Special Bulletin

SP15-337B

Revision B: This release replaces all previous versions

LTD EXTENSION ON ENGINE CURBSIDE

Figure 3

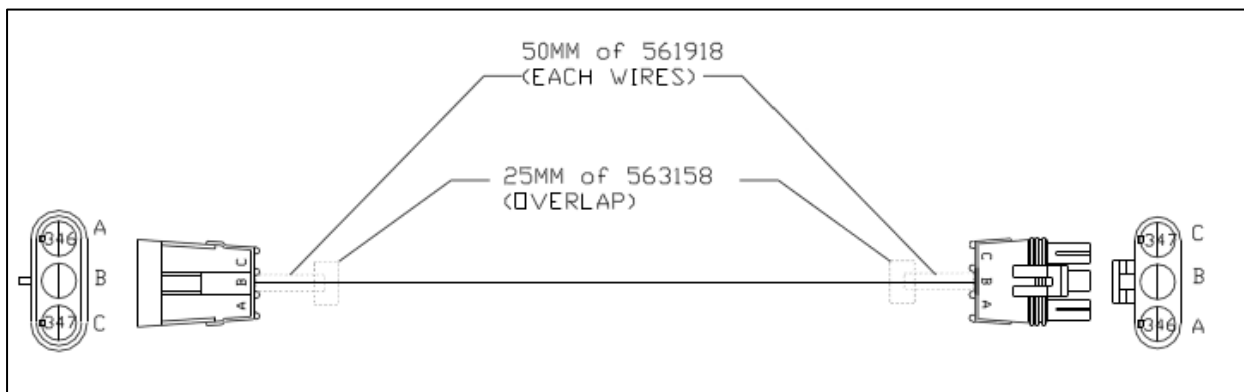
New LTD extension assembly

- Strip cable and wires.
- Slip four 50mm lengths of shrink tube 561918 over each wire.
- Slip two 25mm lengths of shrink tube 563158 over cable.
- Solder and crimp #561567 pins at one end and #561689 sockets at the other end.
- Insert pins in 561781 connector cavities A and C. insert plugs #561565 in cavity B.
- Insert sockets in 561782 connector cavities A and C. Insert plugs #561565 in cavity B
- Heat the shrink tubes in position according to image below.

Figure 4

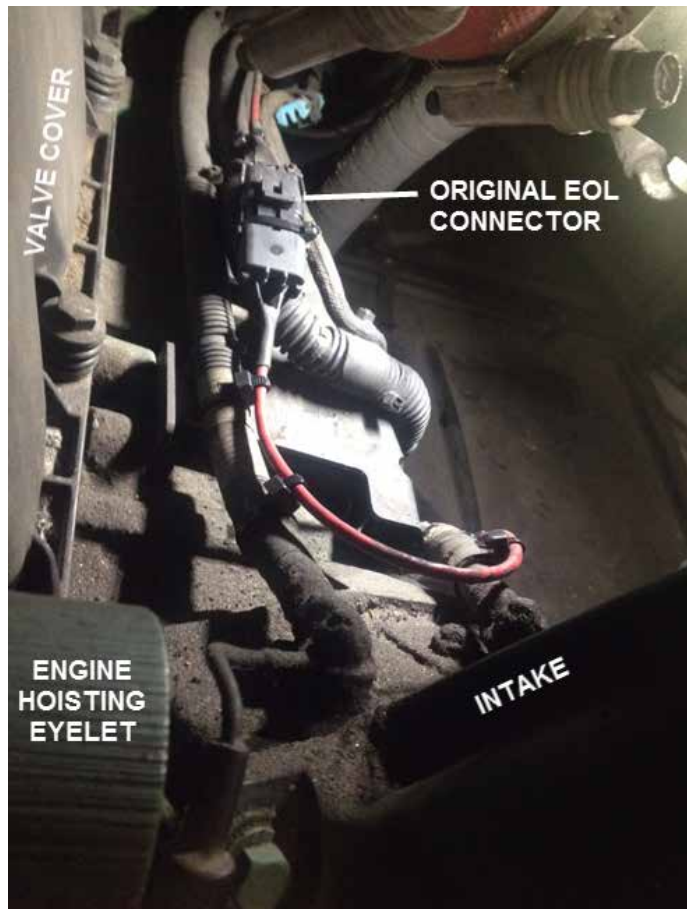
11. On curbside of the engine, next to the intake manifold, remove the “End Of Line” resistor (EOL) from the existing connector on the LTD wire. Reserve for future use.
12. Connect the LTD extension to this connector.

Figure 6

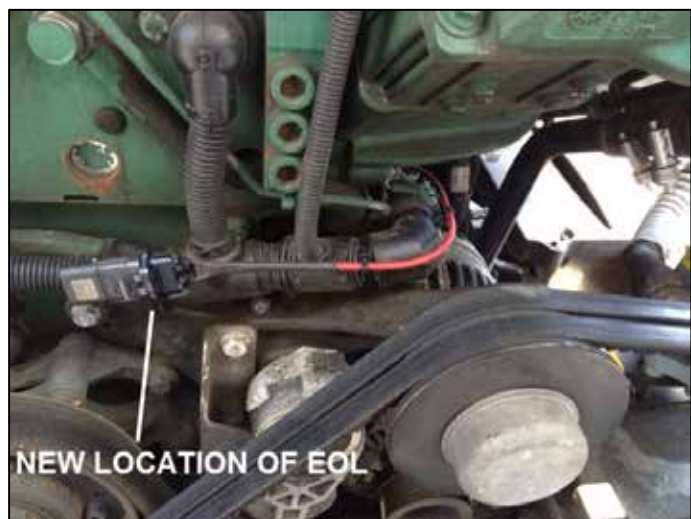
15. Route the LTD wire to a point forward of the alternator. The terminus point may vary slightly from one bus to another.
16. Connect the reserved EOL resistor.
